## NOTICE OF DECISION

FILES: SP-21-17 and RL-02-18

TYPE OF APPLICATION: Site Plan Review for new construction of a 10,750-square-foot cold storage warehouse and a Tentative Plat Review application to replat three lots and vacated right-of-way into one parcel.

# VAN VLEET MEAT CO. COLD STORAGE WAREHOUSE

**VAN VLEET MEAT COLD STORAGE ADDITION  
PROPOSED SITE PLAN**

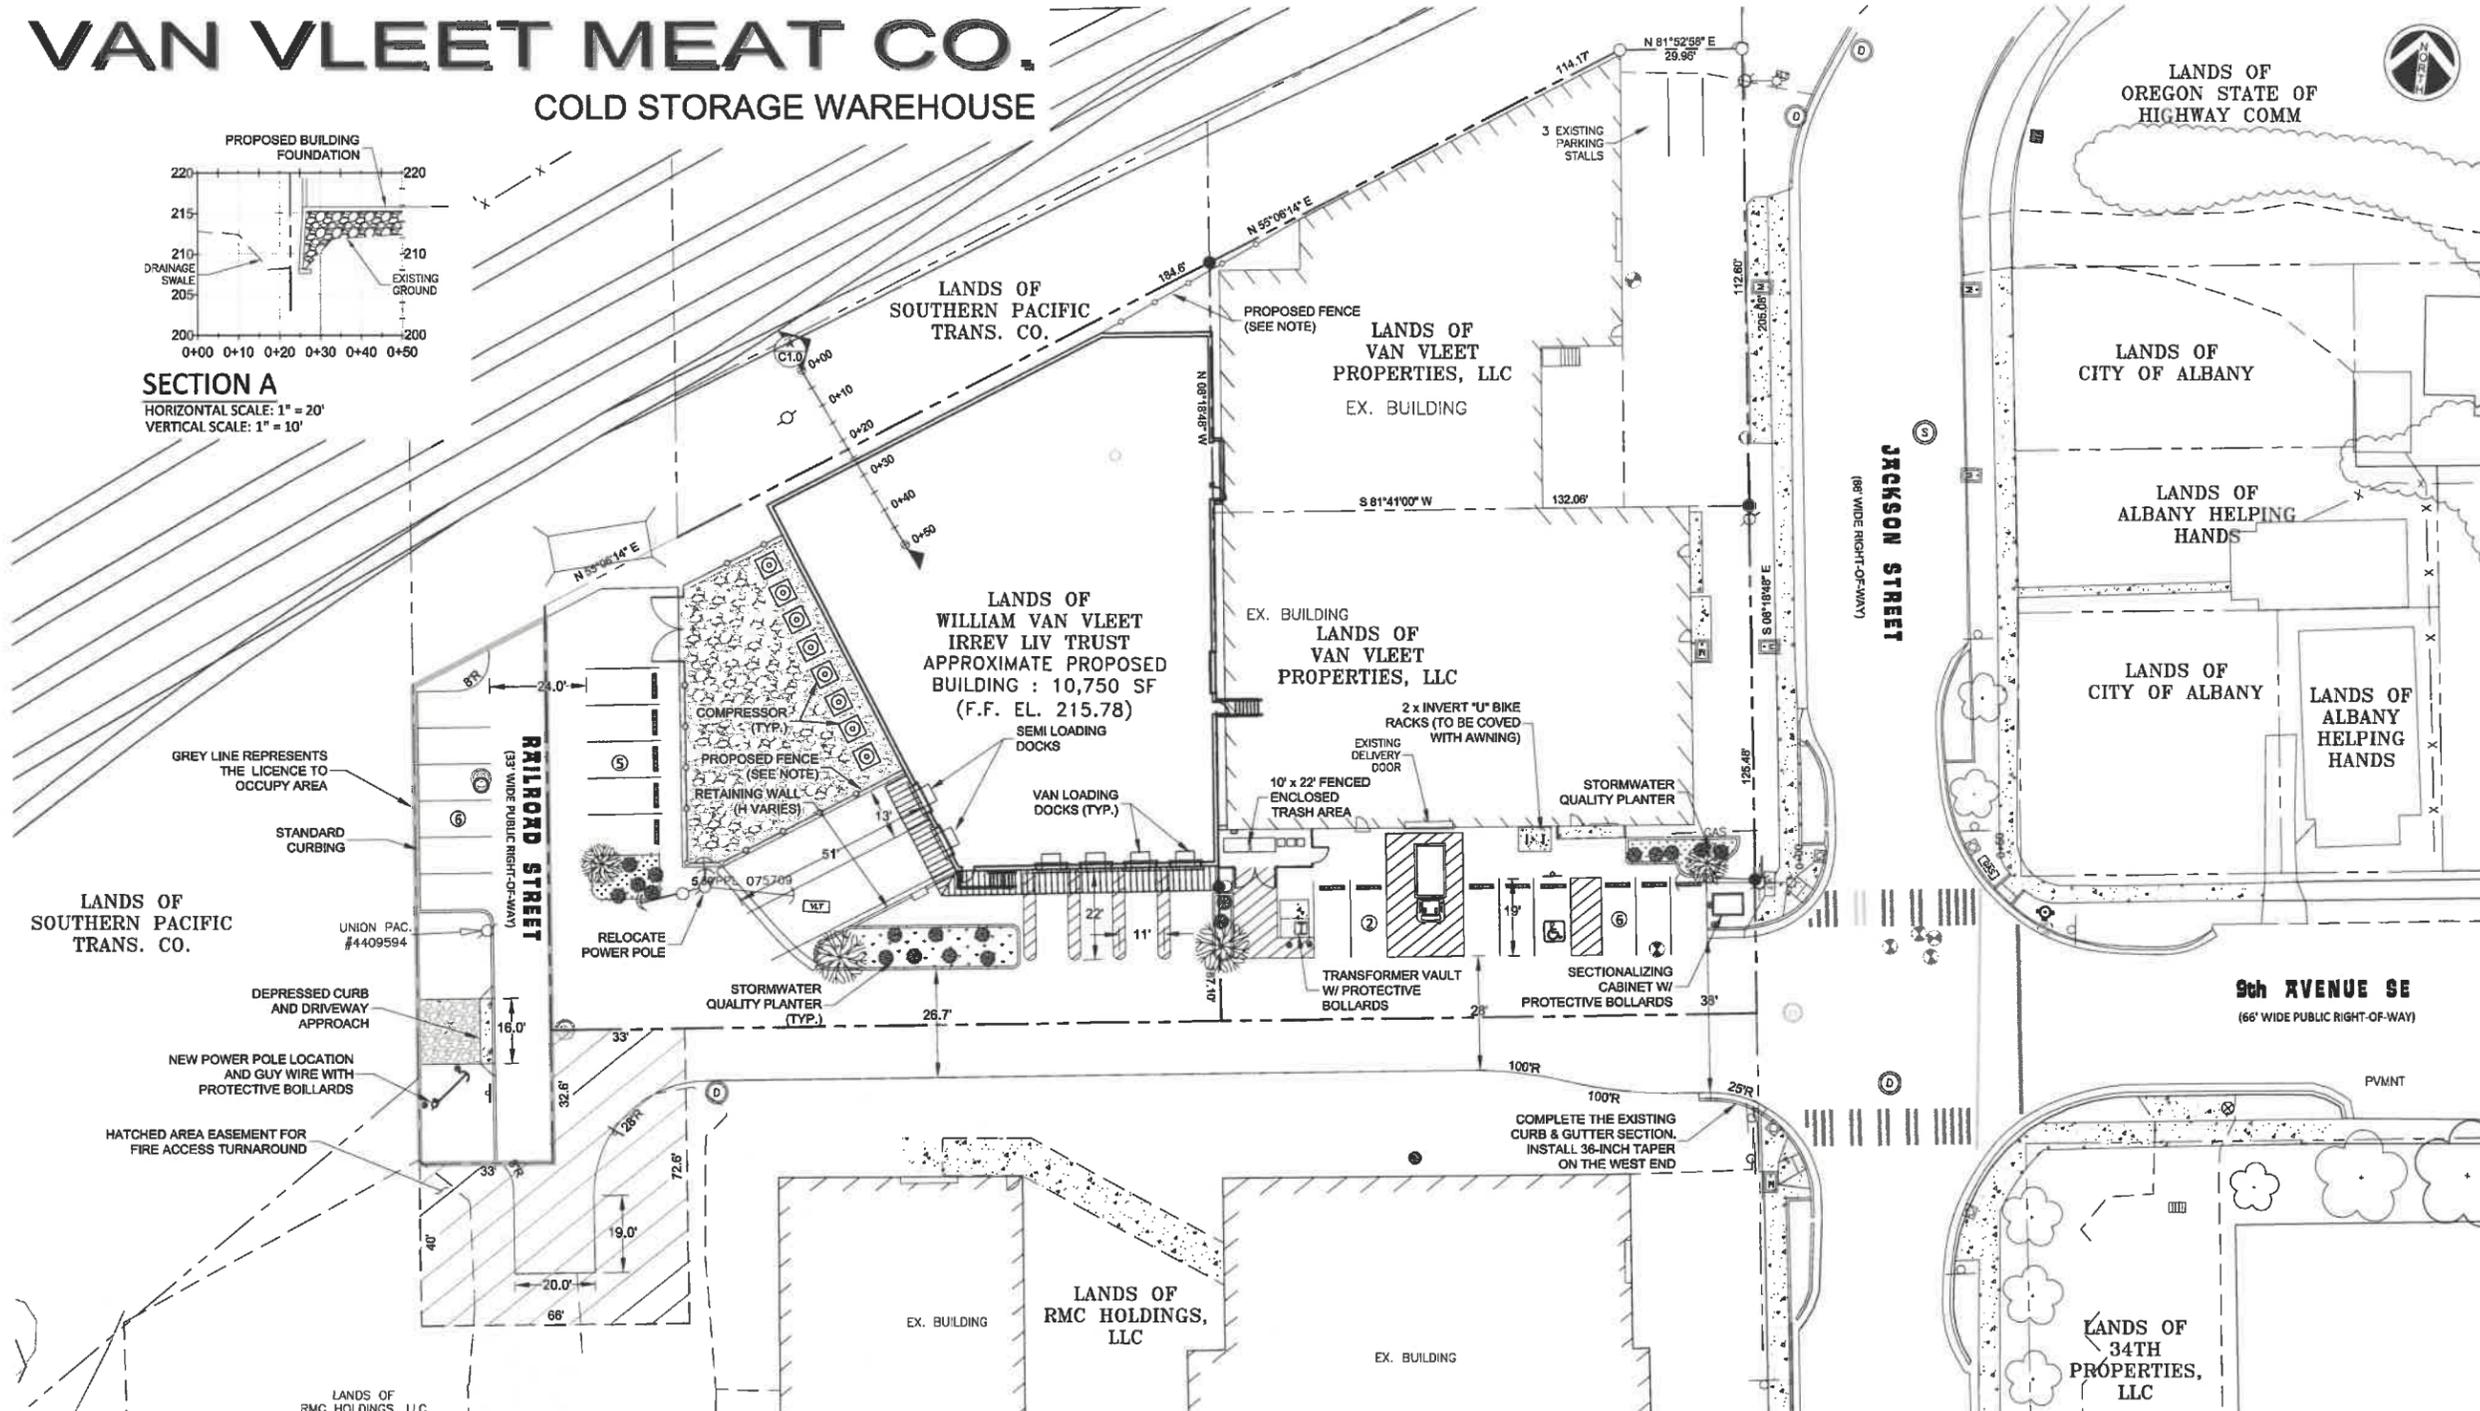
**The project as illustrated does not show any fire apparatus access roads. Designated fire apparatus access roads must be identified on your plans to include annotations showing how fire fighters will access the exterior of all of the proposed buildings.**

**If the vacated portion of 9th St will be used as part of your Emergency Vehicle Access, before the City will approve issuance of a building permit for this parcel, the applicant must provide the Building Official with evidence that the following will occur before construction materials are brought on to the site (OFC 503):**

2. Dead-end fire apparatus roads in excess of 150 feet in length shall be provided with an approved area for turning around fire apparatus (OFC 503.2.5 and D103.4)

4. Turning radii for all fire apparatus access roads shall be provided and maintained at no less than 30 feet inner and 50 feet outer (OFC 503.2.4 & Appendix D 103.3)
